RADIO—REPLACEMENT SPEAKER HAS THREE MOUNTING HOLES INSTEAD OF FOUR—INSTALLATION TIPS

Article No. 02-20-1

FORD: 1995-2000 CONTOUR

MERCURY: 1995-2000 MYSTIQUE

Figure 1 - Article 02-20-1

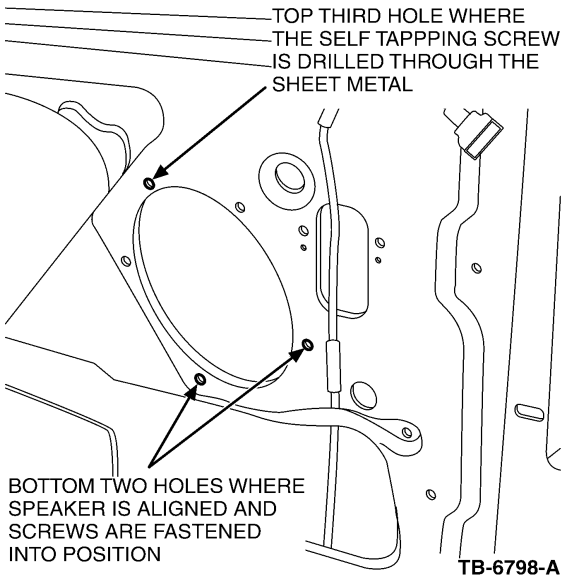
When necessary to replace a door speaker, the new replacement speaker will have three mounting holes instead of four. The four hole speaker is no longer available.

When replacing a door speaker, 2 of the original mounting points will align with the new speaker and 1 additional hole will need to be made to mount the new speaker to the door.

1. Place the window in the up position.
2. Align the two bottom holes on the speaker with the 2 bottom original holes on the inner door panel (Figure 1).
3. Fasten the bottom two screws into position (Figure 1).
4. Using 1 of the original screws, attach the third mounting screw into the top locator hole using a power screw gun. The screw is a metal, self-tapping screw and will cut through the inner door panel sheet metal (Figure 1).
5. Re-assemble the door trim
